the eight one five pine

815 Pine Street
Denny Triangle Urban Center Village
DPD Project # 3007151

Recommendation Meeting Goal:

Obtain final DRB approval to allow the project to move forward to construction.

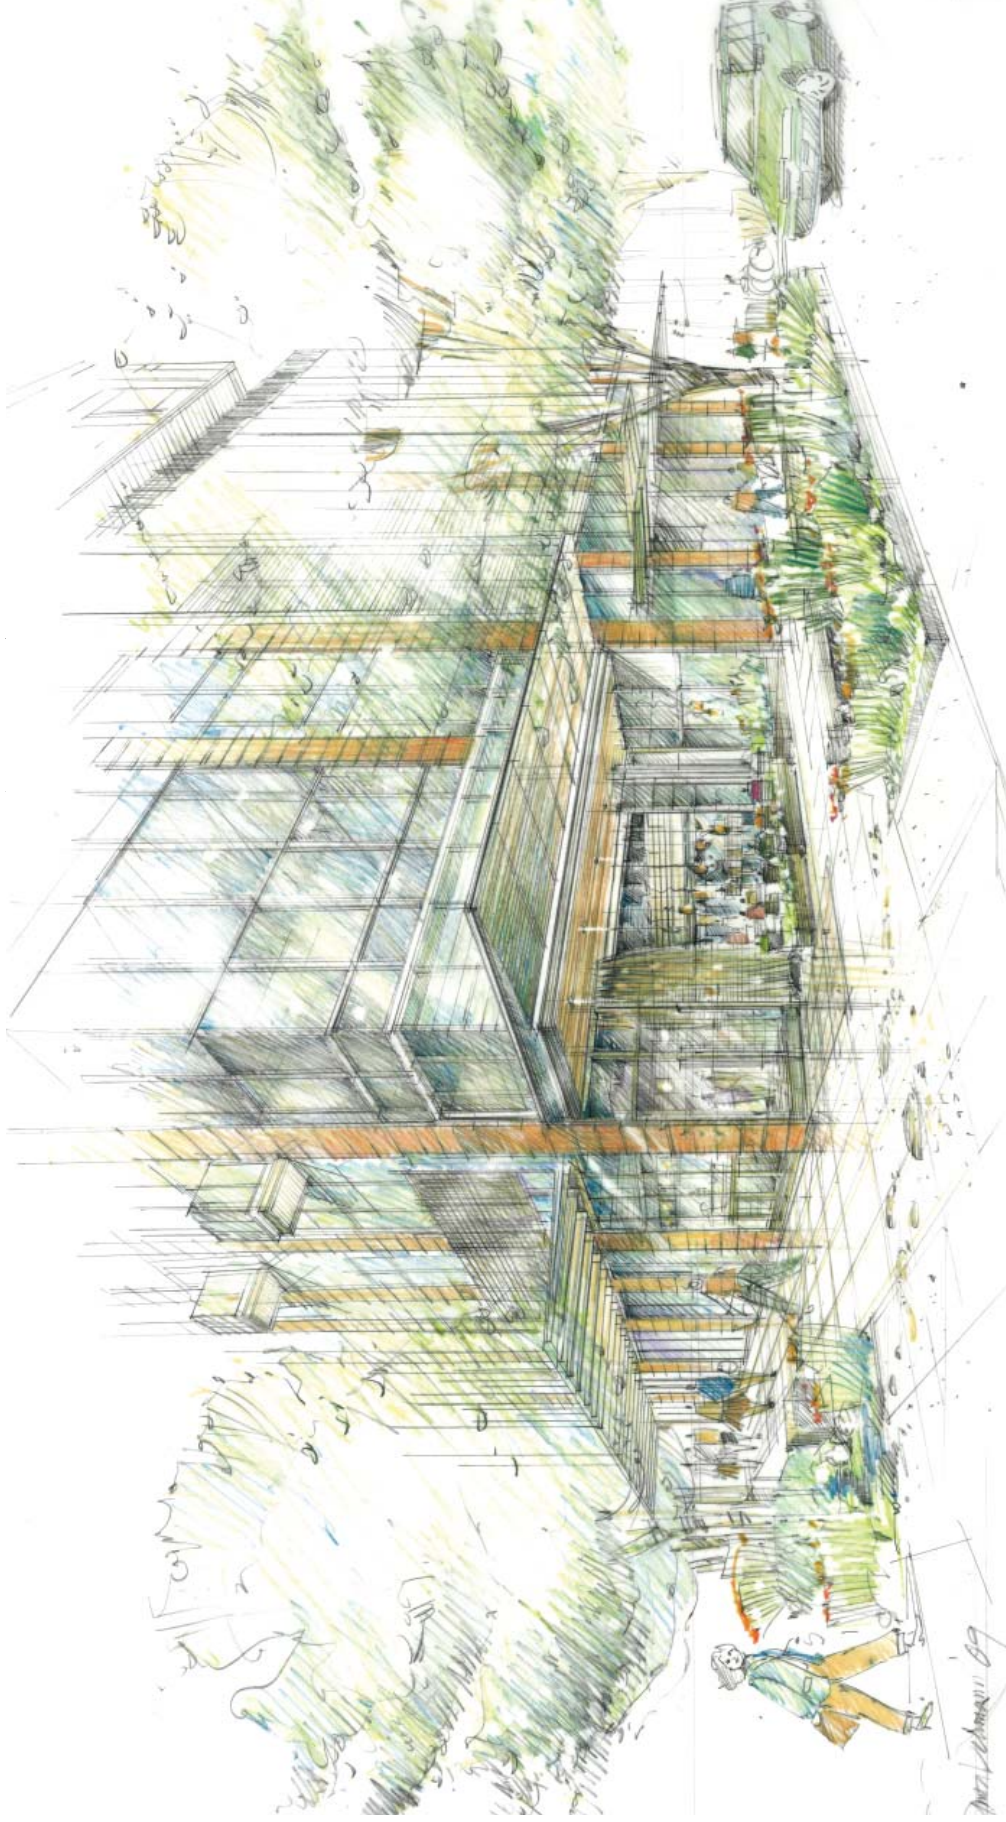
DRB Comments – The proposal with its use of terra cotta, corner cut out and balcony, exposed stairs along Ninth Avenue and potential for suffused illumination from the parking garage, alludes to the Paramount Theater, a city historic landmark. The Board wondered whether the conditions that are important to the Ninth and Pine corner as expressed at the lower levels, should be continued upward to define the corner for its entire height as a means of visually anchoring the structure.

The proposed balcony at the corner and the exposed staircase facing Ninth Ave. are opportunities to create truly elegant architectural elements. The Board looks forward to seeing these features, with so much potential, realized in a contemporary manner that matches the refinement of the Paramount Theater.

Response – The corner of Pine Street and Ninth Avenue is visually anchored by the recessed corner entrance and rooftop balcony which are amplified by contiguous curtain wall façade and defined by the stacked row of balconies. The residential balconies and stair on the east side complement similar uses on the Paramount Theater but are expressed with architecturally finished concrete and clear glass that is consistent with the contemporary tower.

View of Pine Street and Ninth Avenue Corner

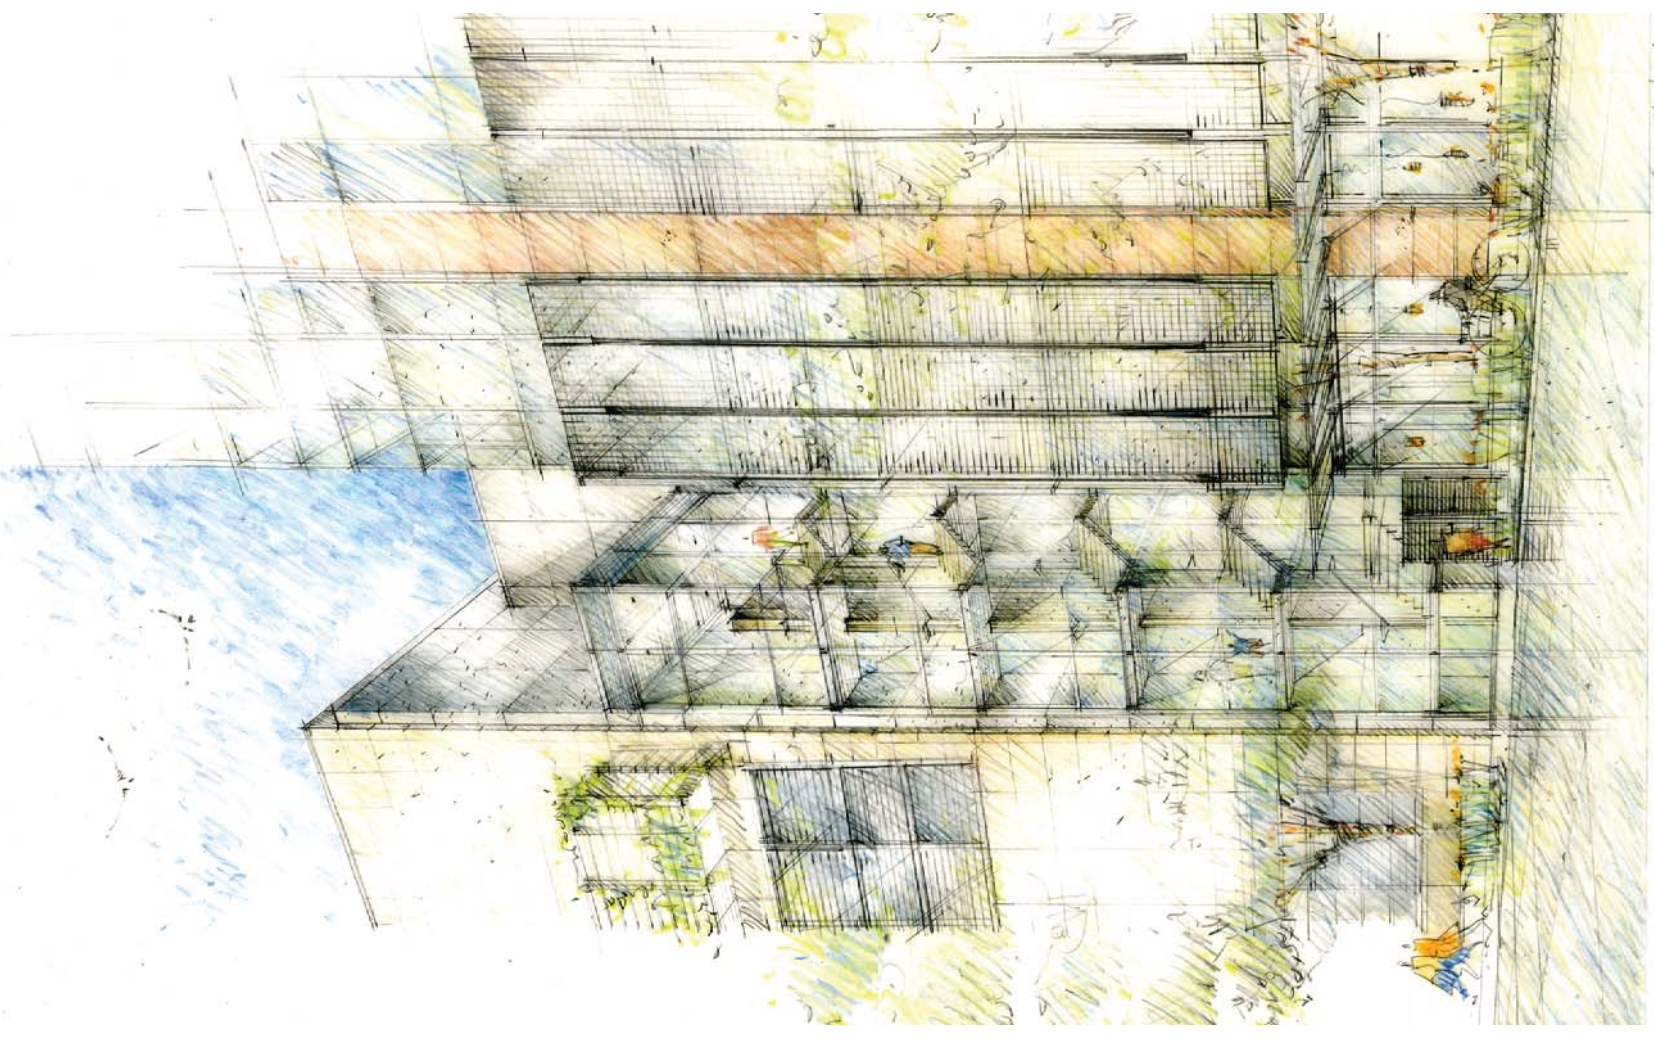
DRB Comments – The proposed treatment of the corner with its second floor balcony, raised sidewalk café and cut out of the façade engages the structure with pedestrian activity at the street; however, the design forces the pedestrian to circumnavigate the raised seating platform and walk beyond the overhead canopy's protection. The second floor balcony is less than the required height of ground floor uses as expected in the Land Use Code. A representation of the second floor plan (and section) would have helped define the how the interior space works.

Response – A covered outdoor dining area is maintained in a configuration that can be expanded in the future. The scale and proportion of the corner is intended to subtly echo the Paramount's entrance and marquee. The balcony level was not feasible.

View from Pike Street of South and East Facades

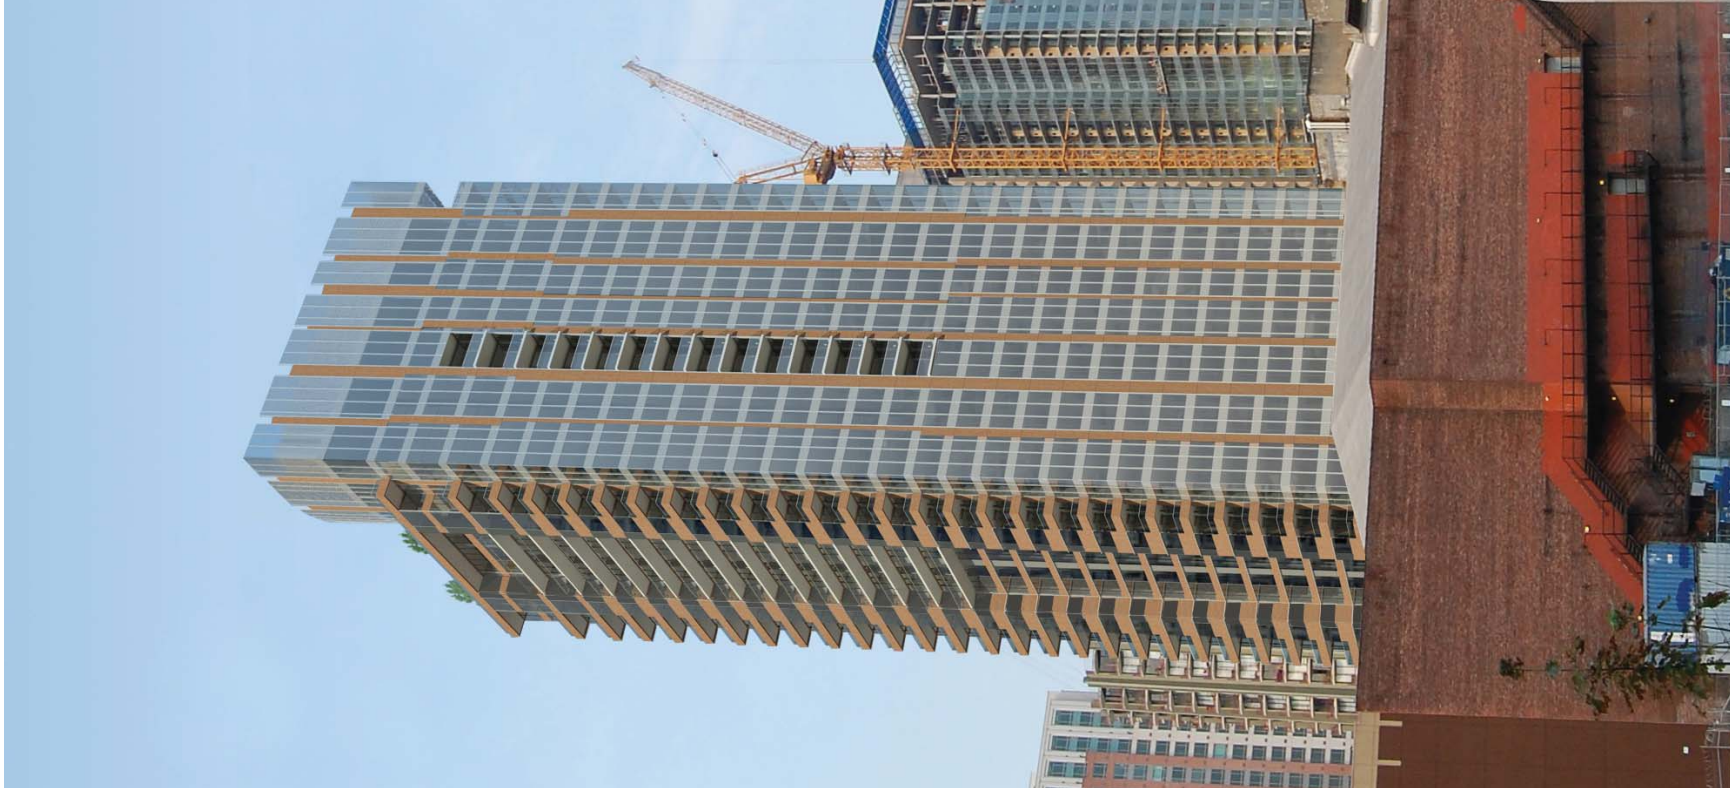
DRB Comments – Recognizing the playfulness of the vertical striations on the north and east elevations, the Board asked that the two facades with horizontal stripes be more assertive. Just as the Pine St. and Ninth Ave. facades subtly express the density of units on each floor, this occurs on the alley and convention center sides as well. In spite of the changes in the height of the spandrels and the width of the balconies, the two minor facades lack the whimsy of their sisters. Unresolved is the transition at the corners from the horizontal to the vertical facades. At the northwest corner, a vertical spine of balconies creates a transition between the facades. At the southeast corner, this transition appears less sure of itself. The architect's attempt to define a base, middle and top lacks clarity. In the small elevations presented in the design review booklet, both the vertical, terra cotta stripes and the homogeneity of color in the façade renderings, overwhelm the distinctions created by the six floor balcony (on Pine St.) and the channel glass proposed for the garage. Unlike the west and south facades, in which the balconies clearly define the shaft, the vertical columns of balconies on the north and east walls do not extend to the base. The curtain wall at the roof top of the north and east elevations lacks resolution---the only distinction between it and the shaft is the lack of balconies. The top should possess clarity and a better resolution. See guidance A-2.

Response – Additional articulation was added to the south and west elevations. The corner balconies were also made larger to better articulate where the two façade concepts meet. Overall, the full tower is intentionally composed with a recessed balconies and changes in materials to achieve a more subtle articulation of traditional base, middle and top. The rooftop is expressed at primary 'public' corner of the tower where the curtain wall glazing continues to the sky

View from Pine Street

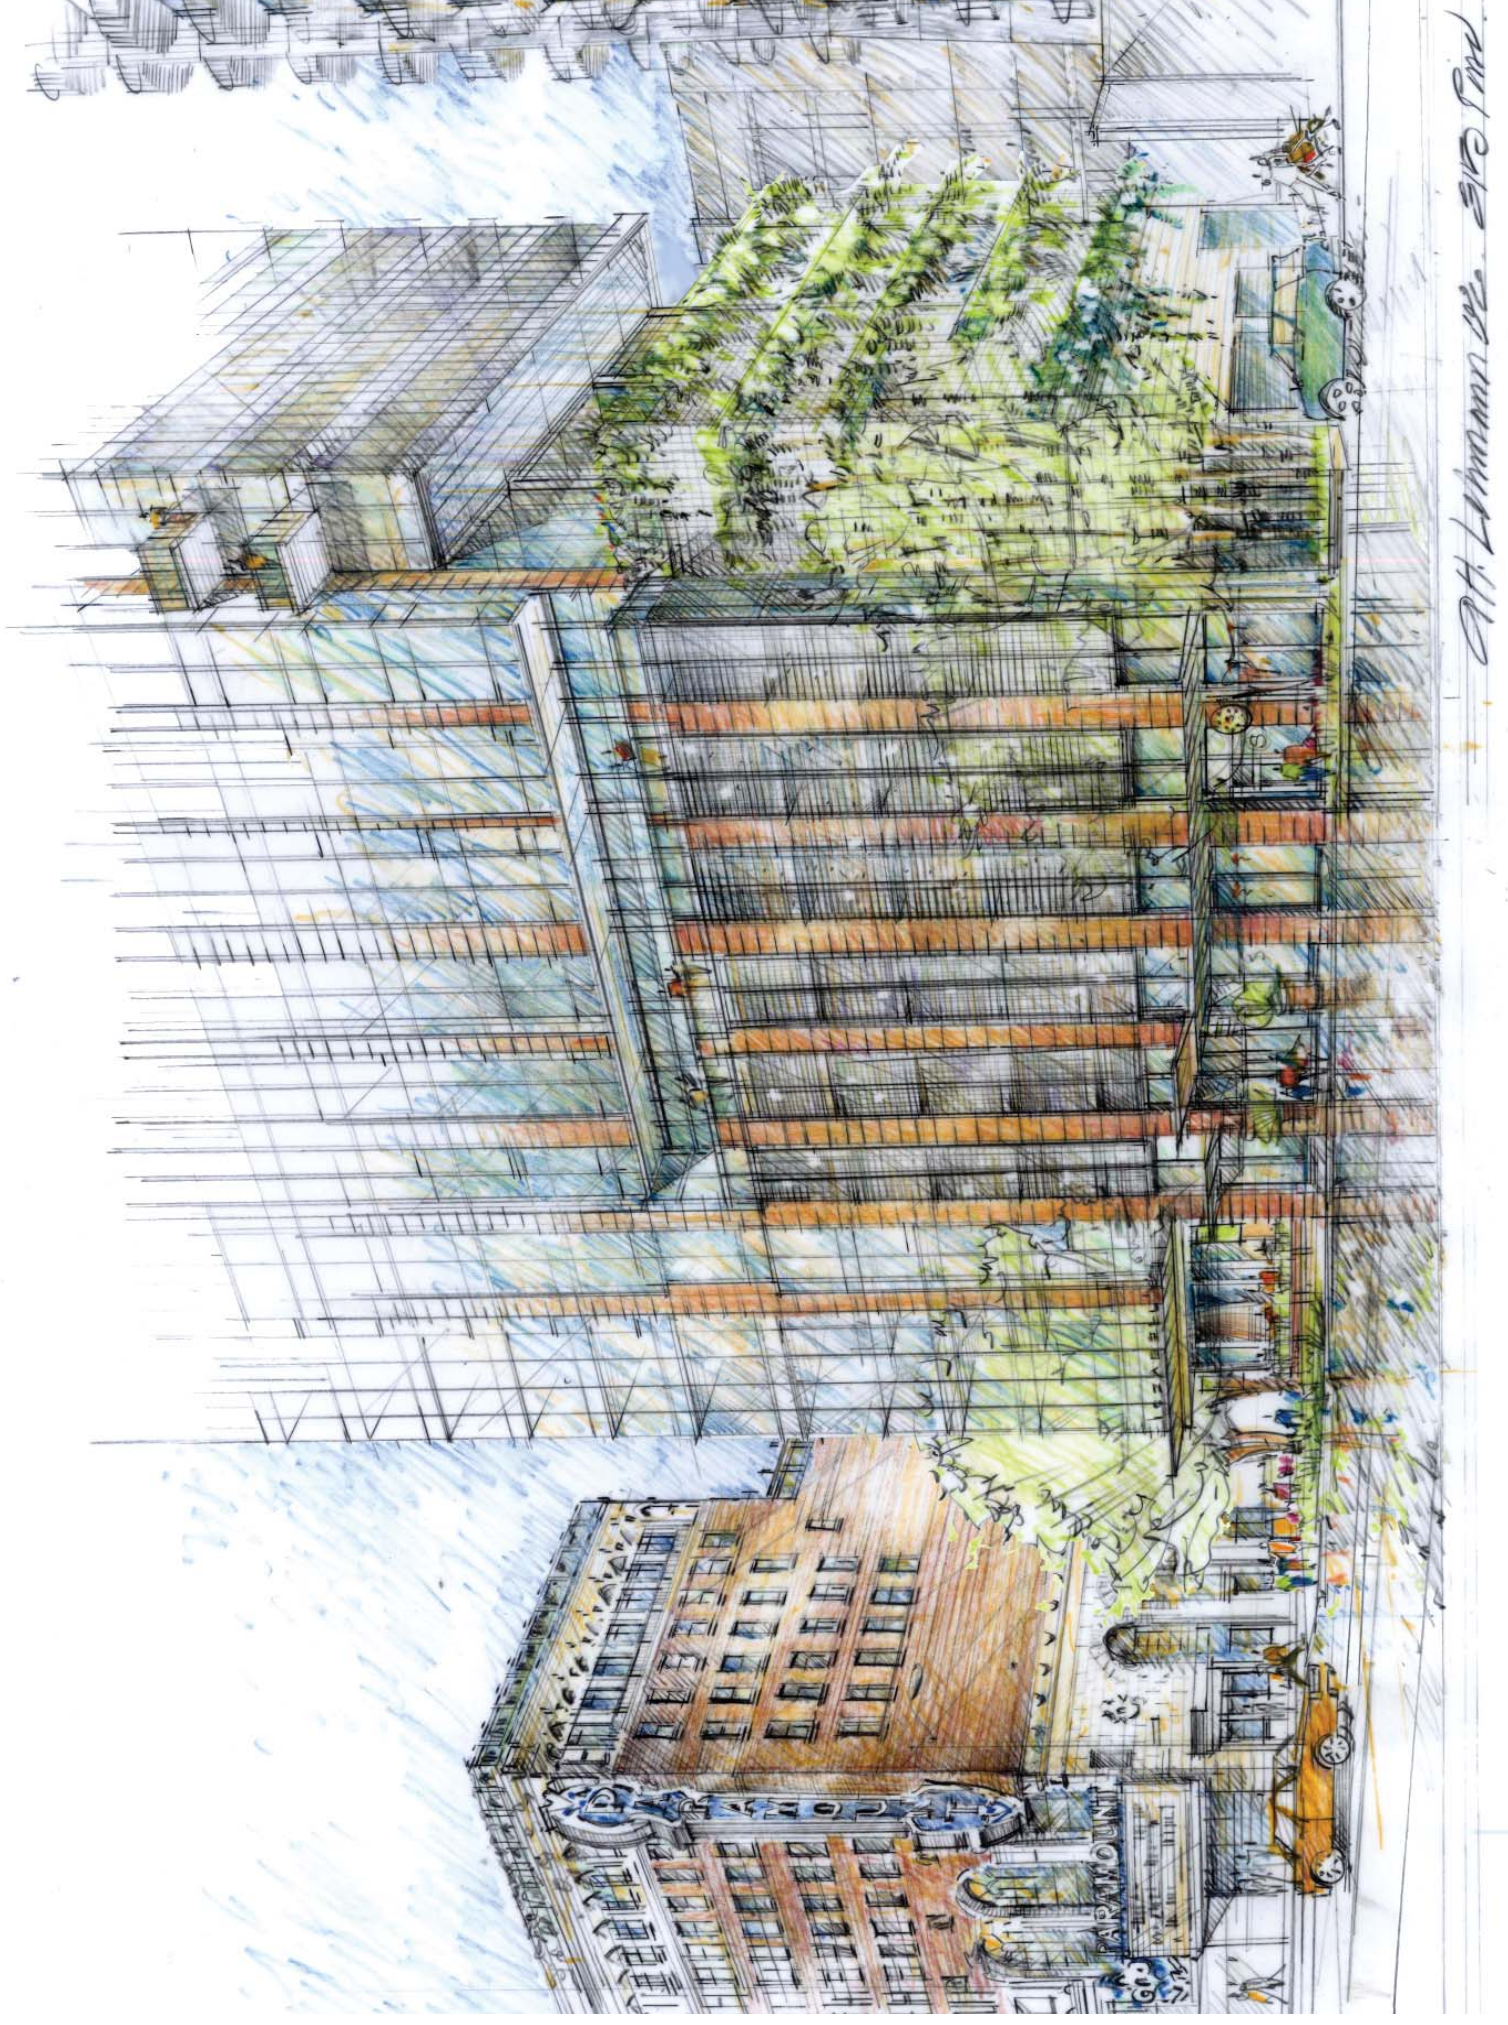
DRB Comments – The Board supported placing the residential entry on Pine St., a shift from the guidance given at the earlier meeting. Overall, the Board expects a more realistic representation of materials at the street and garage levels. Future drawings should delineate the pedestrian experience at the ground plane. Provide analysis of the relationship of the restaurant (retail) floor level and the sidewalk level for the Recommendation meeting; for example, how does the sloping sidewalk relate to the restaurant?

Response – The design provides three different uses along Pine Street to maximize pedestrian activity. A grand 20'+ height is provided both here and along Ninth Avenue. A smaller human scale four foot storefront and glass canopy module is also provided. A slight horizontal rib is introduced into the vertical "burnt ochre" colored metal panel bands to provide greater scale and detail.
